SHEARON HARRIS NUCLEAR POWER PLANT, UNIT NO. 1
DOCKET NO. 50-400/LICENSE NO. NPF-63
SUPPLEMENT TO TECHNICAL SPECIFICATIONS 5.6.1.3.a AND 5.6.1.3.b –
INCORPORATION OF UPDATED CRITICALITY ANALYSES TO REFLECT
REMOVAL OF CREDIT FOR BORAFLEX IN BWR SPENT FUEL POOL
STORAGE RACKS

SHEARON HARRIS NUCLEAR POWER PLANT, UNIT NO. 1
DOCKET NO. 50-400/LICENSE NO. NPF-63
RESPONSE TO ACCEPTANCE REVIEW REGARDING
AMENDMENT TO REMOVE CREDIT FOR BORAFLEX IN BWR
SPENT FUEL POOL STORAGE RACKS

The staff completed the acceptance review of the application and finds that the information delineated below is necessary for the staff to conduct the detailed technical review.

Reactivity Effect of Geometry Model

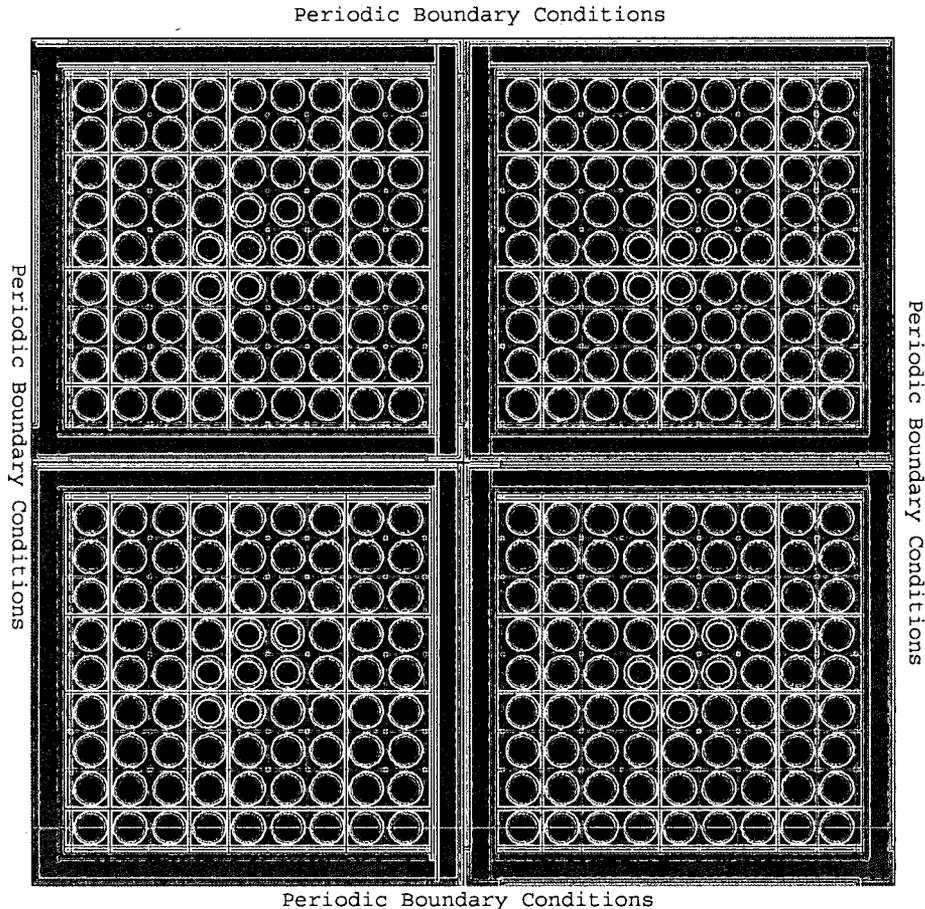
- a) *Figure 3 of HI-2043321 shows the calculational model of a "typical" storage cell. Is this model an approximation of the actual configuration? If so, please show the impact of the approximation on the calculated reactivity.*

Response: The storage cells are composed of stainless steel boxes, joined at the corners in an egg-crate structure. The external box side is equipped with a stainless steel sheathing which holds the Boraflex neutron absorber in place. These boxes are then arranged in a checkerboard pattern, where four storage cells form "developed cells" that can also store spent fuel assemblies. The MCNP model is developed as shown in Figure 3 of HI-2043321. All material thicknesses (stainless steel and water) are preserved and the Boraflex is completely neglected. Additionally, the storage cell pitch is modeled at 6.22 inches, conservatively reduced from the nominal storage cell pitch of 6.25 inches. These conservatisms would more than offset any small reactivity effect associated with the geometry modeling.

An additional MCNP4a calculation was performed with the storage cell box and stainless steel sheathing modeled explicitly.

Geometry	Calculated k_{eff}	Sigma
Figure 3	0.9576	0.0003
Explicit geometry	0.9585	0.0003

The results in the table show that the simplified geometry modeled in the main part of the report provides an accurate representation of the actual geometry. While the explicit geometry provides a slightly larger k_{eff} , the small increase would be offset by modeling the storage cell pitch at 6.25 inches.
